**Project: IEEE P802.15 Working Group for Wireless Personal Area Networks (WPANs)**

**Submission Title:** [DS-UWB Responses to TG3aVoter NO Comments]

**Abstract:** [Response to NO voter comments and feedback regarding the DS-UWB (Merger #2) Proposal]

# Performance at Very High Rates

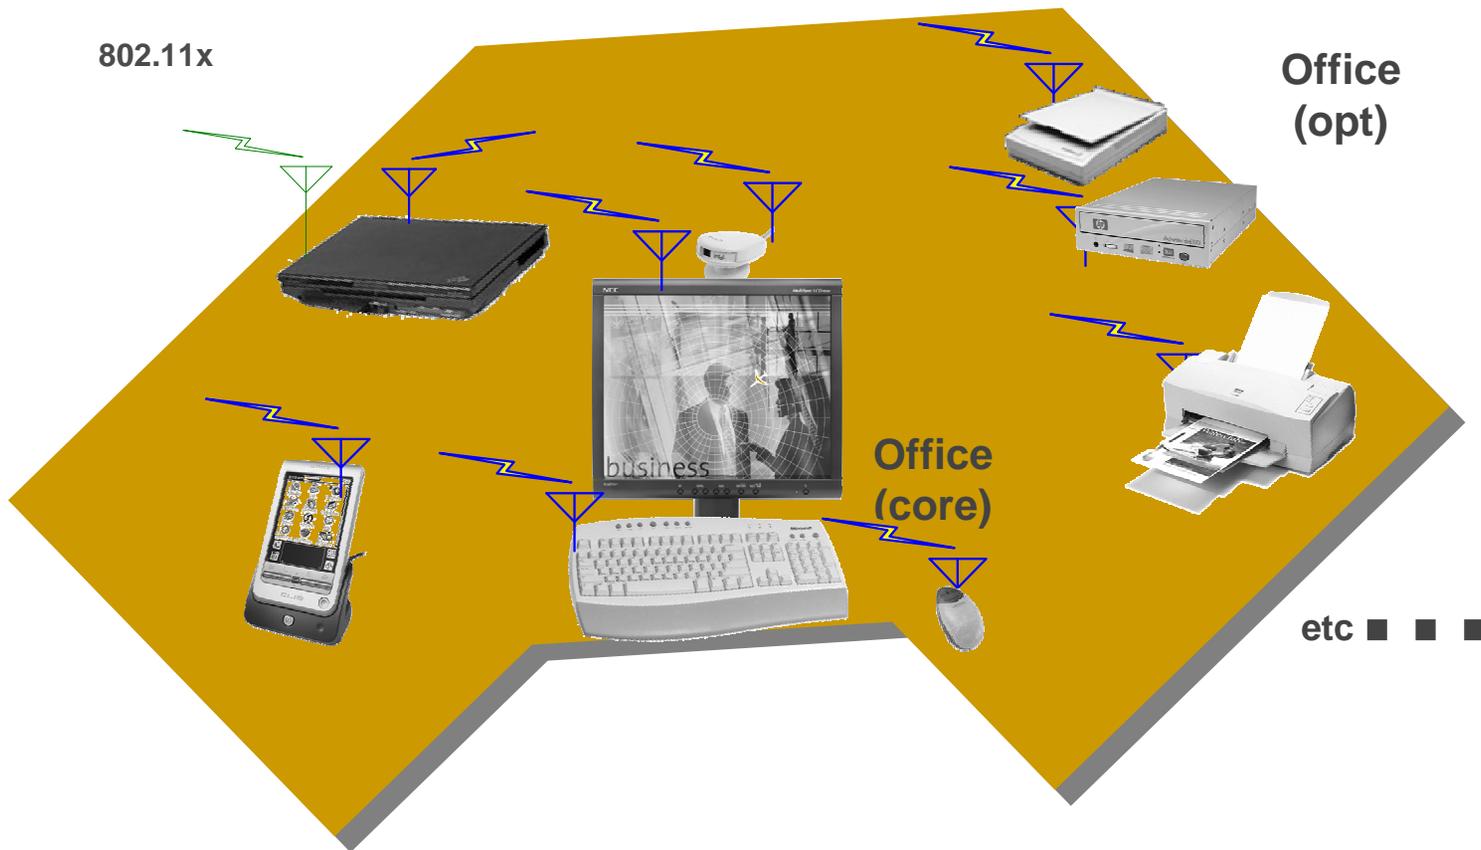
- My skepticism about the practicality of the unprotected 1Gbps data rate has been confirmed by recently published simulation results e.g. in 802.15-04-0483r5. For example, CM1 range for low band 1000Mbps on slide 24. Even in the case of no interferers, the packet error rate could not be shown to drop below 39% at any distance. Therefore, the authors have a way to go before they have convincingly shown a path to robust transfer of Gigabytes of information in a real world environment. If this system is to rely on ARQ as has been suggested, then the total system throughput has to be demonstrated in the context of the 15.3MAC MIFS and SIFS times, the bandwidth allocated to ARQ retries, the impact of multiple piconet interference, etc. If such an overall system analysis for Gbps data rates were presented in a convincing way, I would consider changing my no vote to a yes.

- We do not agree with these assertions
- Packet losses typically leads to retransmission, not to data loss
- UWB applications requiring 1 Gbps identified in multiple documents

- DS-UWB has multiple modes (with FEC) supporting 1+ Gbps (2 bands)
- Simulations in different AWGN and multipath channel conditions
- This is the only proposal considered by TG3a that has demonstrated the capability to satisfy this 1 Gbps requirement from the SG3a CFAs & TG3a Requirements Document
  - No MIMO or higher order modulation (e.g. 16-QAM) is required

# 90% Outage Comparison High Rates

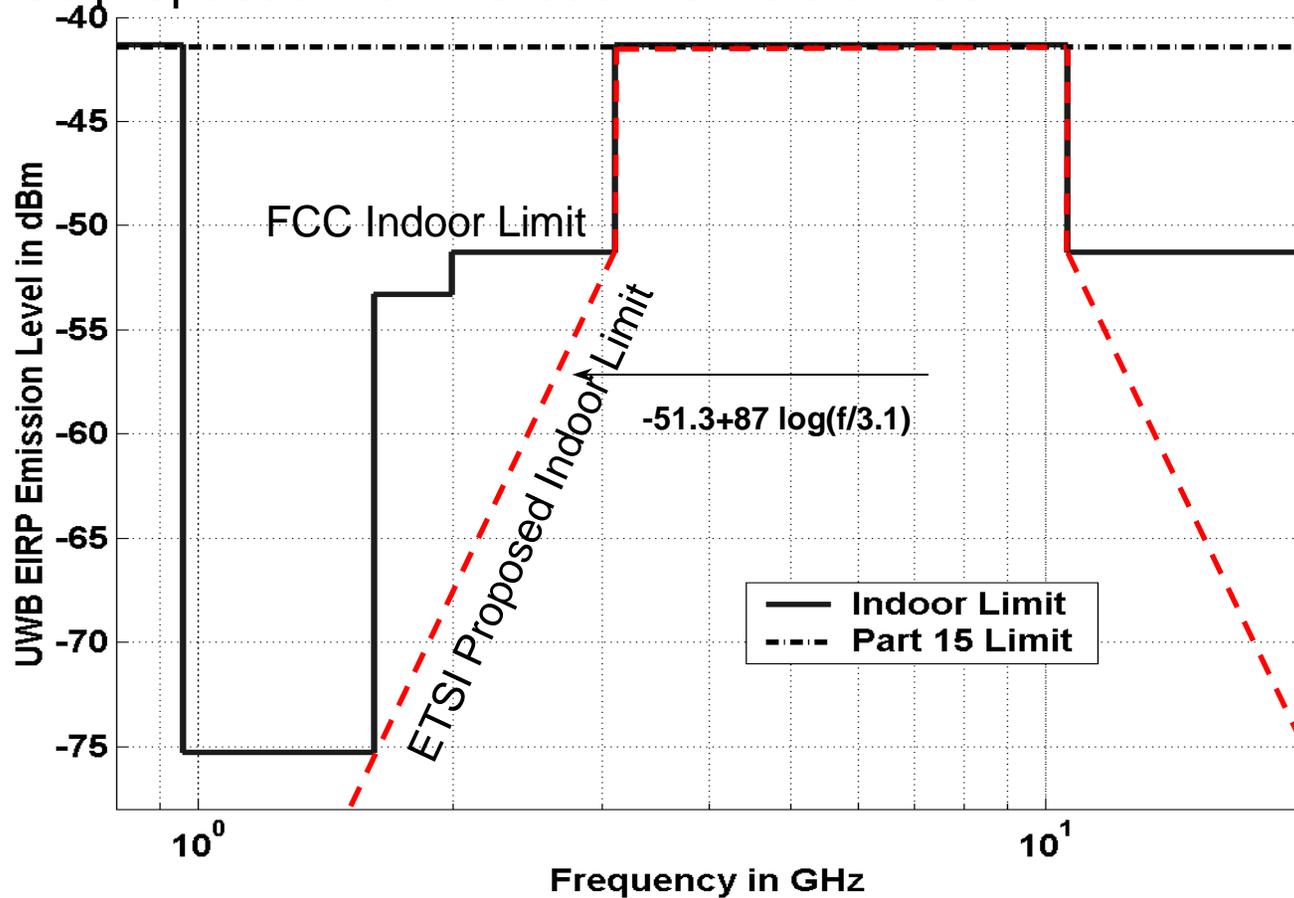
- A comparison of MB-OFDM and DS-UWB at higher data-rates has not been consistent with the information presented by DS-UWB for the 90% outage range (at 500 Mbps, 3.0 m for CM1 and 1.9 m for CM2 in DS-UWB, while at 480 Mbps, 2.9 m for CM1 and 2.6 m for CM2 in MB-OFDM). I hereby question if the DS-UWB comments such as: DS-UWB takes full advantage of UWB propagation, and DS-UWB performance excels as speed goes up. Performance difference is natural consequence of channel physics. If as given in the DS-UWB proposal, have any technical ground. A convincing explanation is required before ever reconsidering my NO vote.

Channel Model	DS-UWB 500Mbps	MBOFDM 480Mbps	DS-UWB advantage	DS-UWB 660Mbps	MBOFDM 480Mbps	DS-UWB advantage
CM1	4.6	3.2	44%	4.2	3.2	31%
CM2	3.7	3	23%	3.2	3	23%

Theoretical Root-Raised Cosine pulse shape showing OOB roll-off

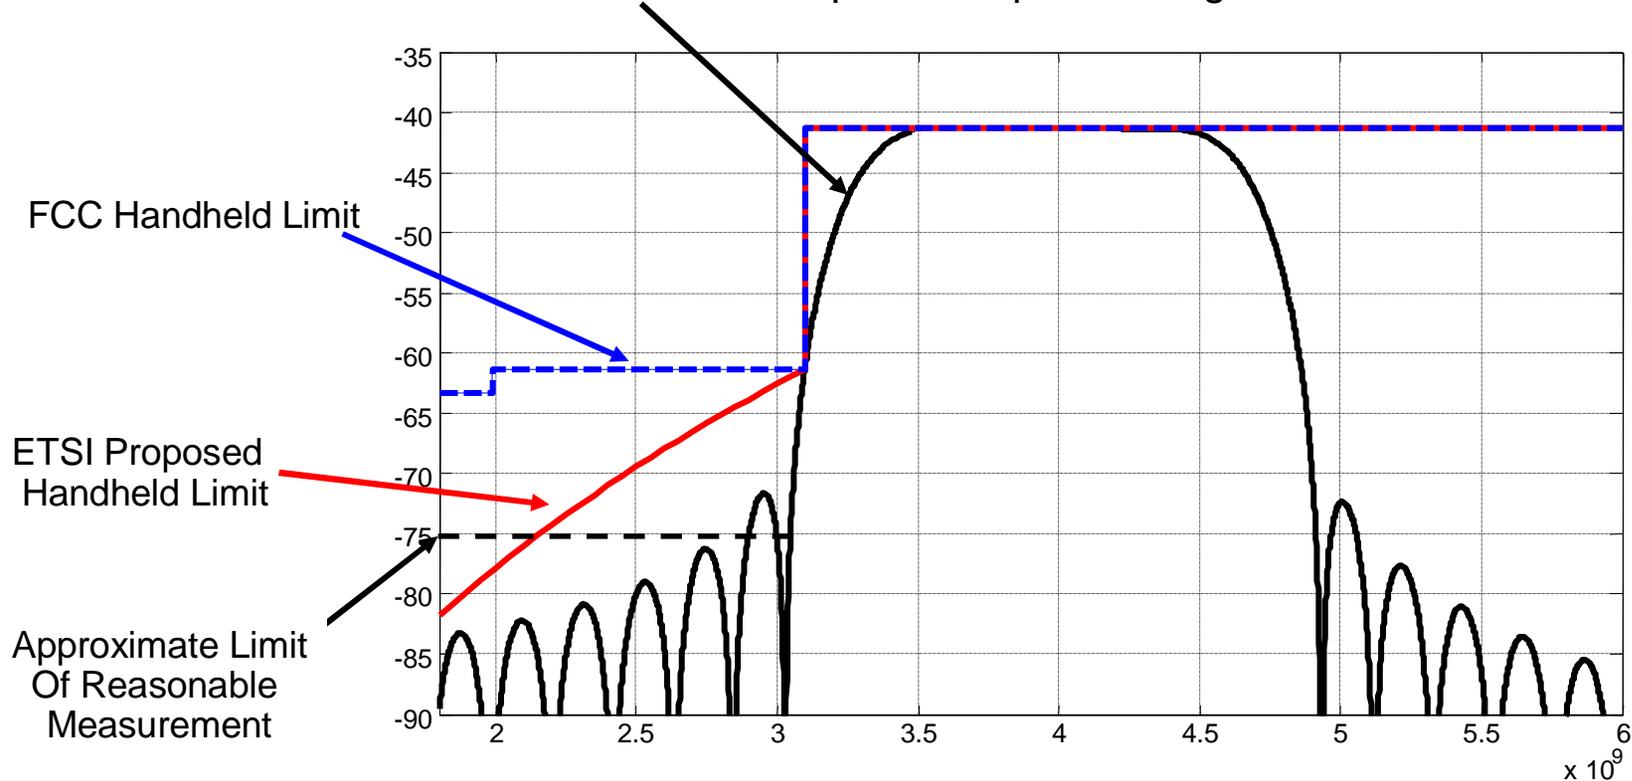
- I would like you to quantify the impact on the DS-UWB system of having to meet strict out of band emissions requirements for services such as IMT-2000 etc. corresponding to proposed protection levels being discussed in ITU-R, etc.

- Lack of an effective mechanism to solve out-of-band and in-band interference for incumbent and future radio service operators is a serious disadvantage with the DS-UWB technology. MBOA has proposed MB-OFDM as a solution to meet both performance and interference mitigation; at present, it is the only one UWB technology that provides a mechanism to coexist with other radio services. As being discussed at ITU-R, CEPT and other regulatory meetings, UWB interference is a global issue, and industry needs a standard solution that meets both performance and interference mitigation. Techniques proposed from DS-UWB in the past either accompany an excessive performance drop or lack technical feasibility. Without an effective technical remedy for DS-UWB, it is extremely difficult to reconsider my NO vote.

- Natural pulse shape of RRC rolls-off quickly outside operating band
- Further control of emissions for co-located applications is possible

# OOB Emissions: Measurements of MB-OFDM

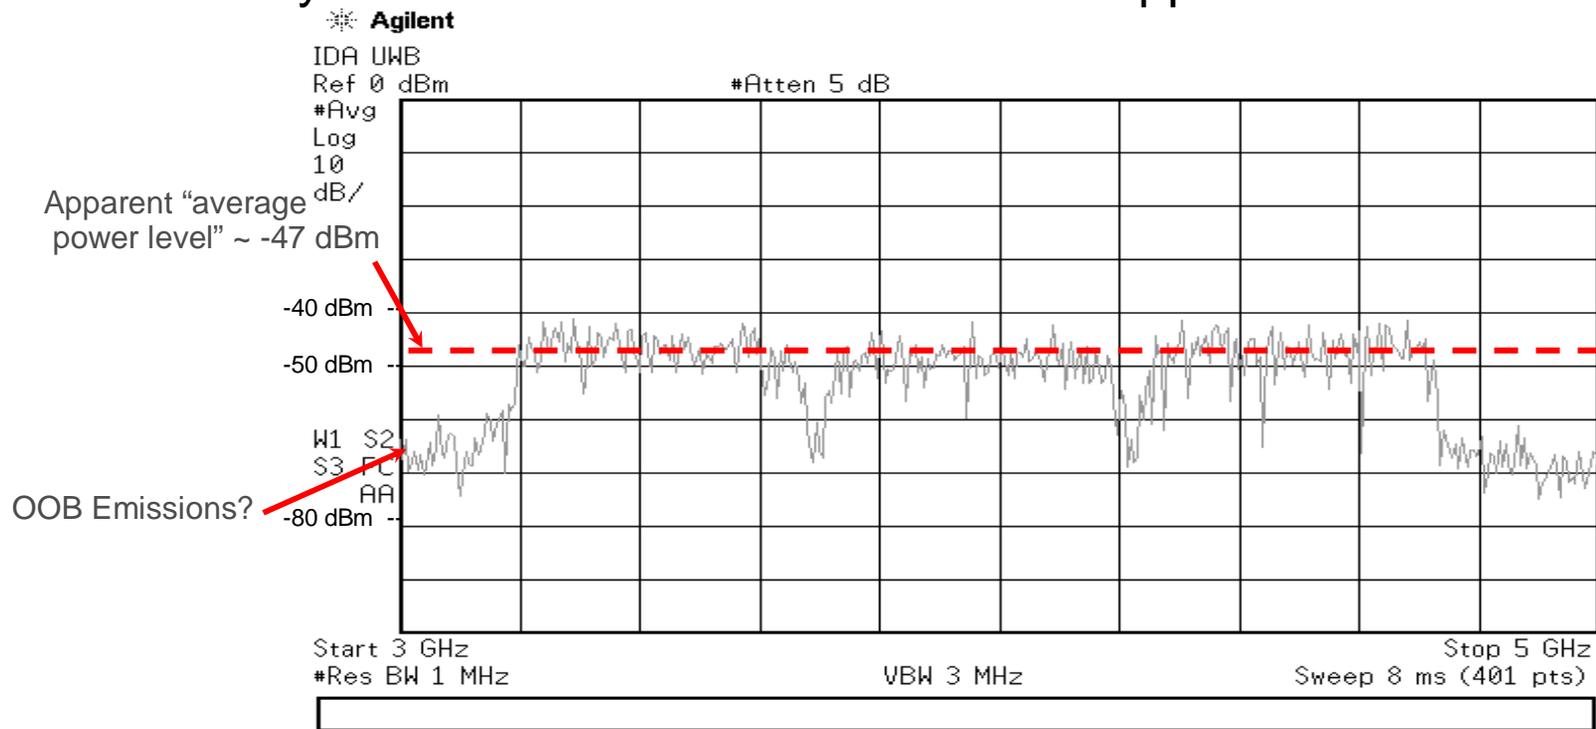
- Commenter indicates that only MB-OFDM can meet OOB emission levels required to coexist with other systems
- Publicly released measurements do not support this conclusion

# Simple Example of Pulse Shaped to Create a Notch

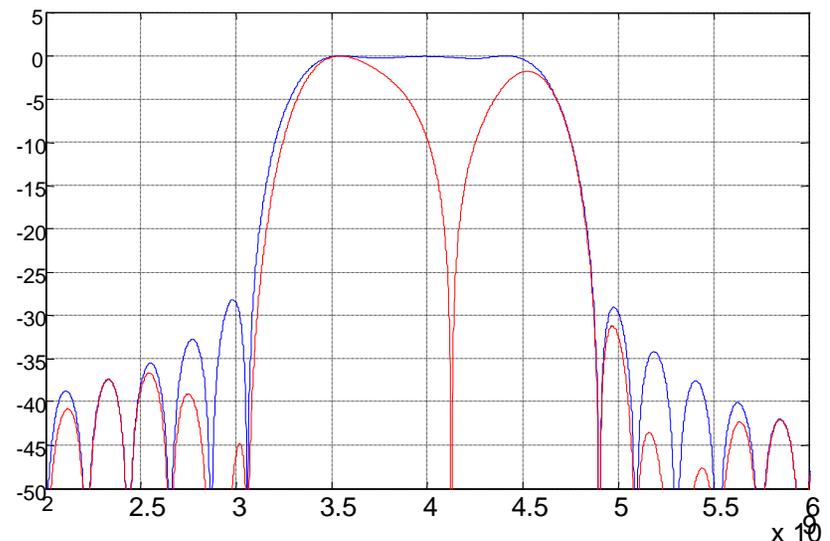
- Comments
  - Any attempt to change the spectrum will generate ISI which will make the equalizer problem even worse
  - Spectral shaping of DSSS introduces ICI and rapidly degrades performance
  - This pulse shaping will also severely degrade the performance
- Response:
  - Pulse shaping lengthens the pulse only marginally
  - A well-designed receiver is already designed to tolerate channel dispersion of 50+ ns and is relatively insensitive to pulse shape – the notch looks like part of the channel
  - Conclusion: Pulse shaping does not cause unmanageable ICI or ISI

- Pulse shaping lengthens the pulse only marginally
- A well-designed receiver is already designed to tolerate channel dispersion of 50+ ns and is relatively insensitive to pulse shape – the notch looks like part of the multipath channel
- Conclusion: Pulse shaping does not cause unmanageable ISI

# ADC Complexity

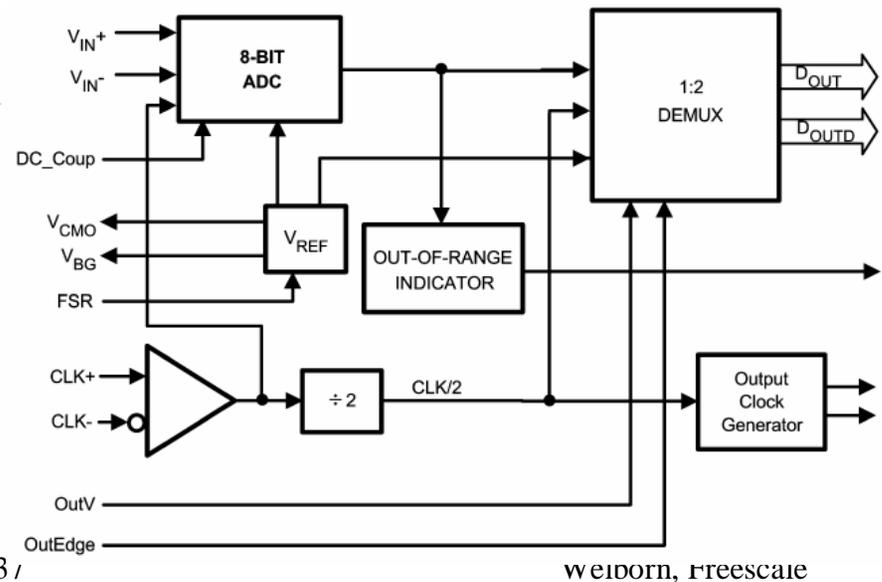
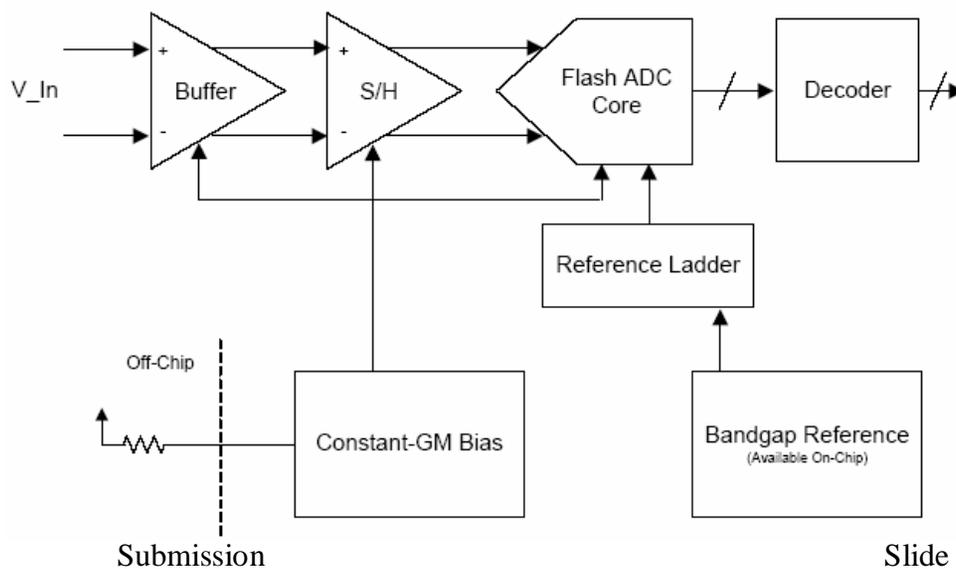
- Comment:
  - The ADC speed and amplifier quality seem to dictate implementation in an exotic process, which in my humble opinion would place a significant damper on adoption. Selecting a standard with significant adoption hurdles will encourage fragmentation of the medium, as lower-cost, higher performance technologies pass by the standard.
- Resolution:
  - ADCs at speeds and quality requires for DS-UWB are already available in commercial products

# DS and MB-OFDM Filters Remove OOB Interference

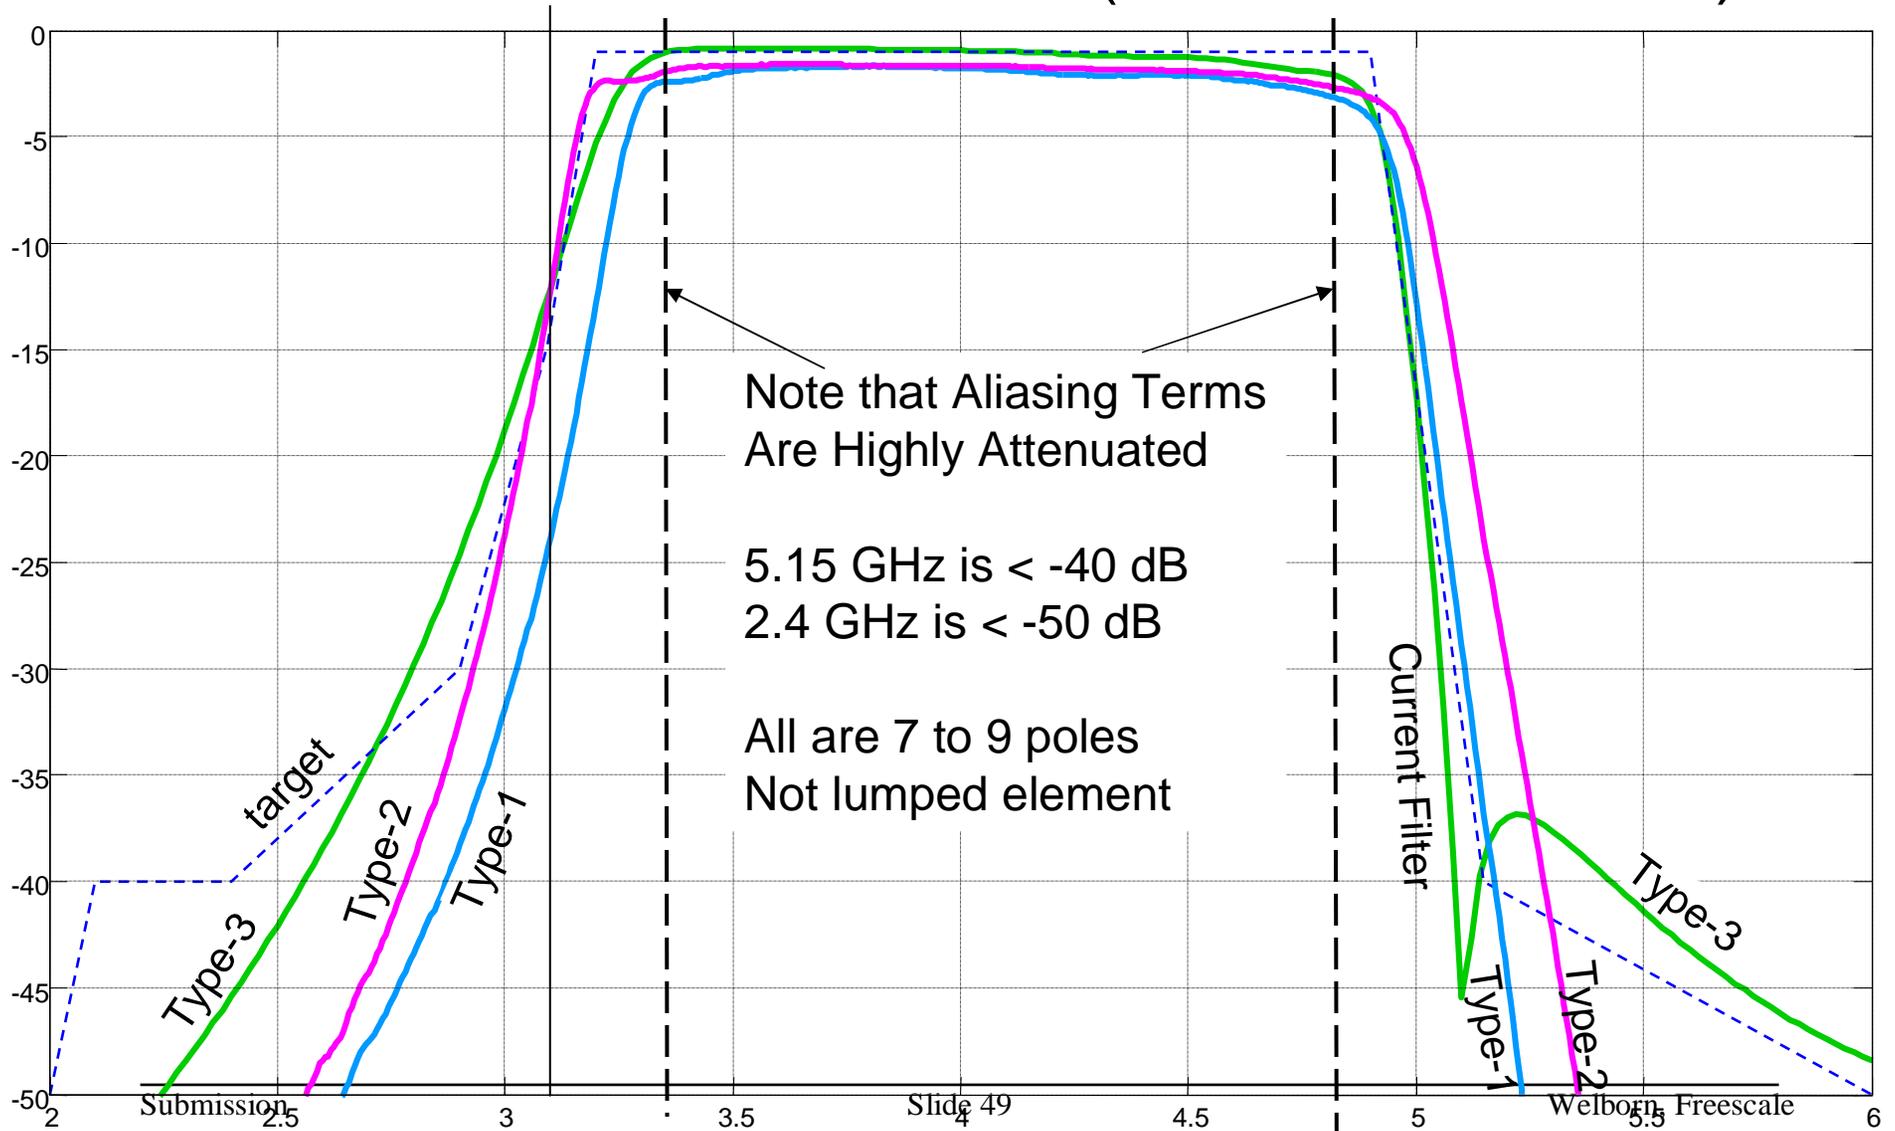
- Also, since there is no over-sampling proposed, it is easy for strong OOB signals to aliased into the 1.3 GHz wide passband. The degree of analog filtering necessary to protect such a system from alias bands has not been discussed. I would consider changing my no-vote to a yes, if the authors of merged proposal #2 could show their analysis of the order of filters required at baseband and at RF to achieve a 1m separation requirement from other unlicensed services in the UNII and ISM bands. Once the required filter orders have been established, we need to be convinced that such filters can be built on-chip with the required intrinsic bandwidth (1.3 GHz).

- I would consider changing my no vote to a yes, if it could be shown that the required on-chip filtering can be integrated with low die area in a mass-market, low cost, process.”

- OOB energy must be removed so LNA is linear for all radio types
- Once the LNA is linear, SNR is key
- Pros and Cons of On-chip versus Off-chip RF filtering is a design choice that has similar trade-offs for either proposal
- Manufacturers are free to choose based on the target market requirements
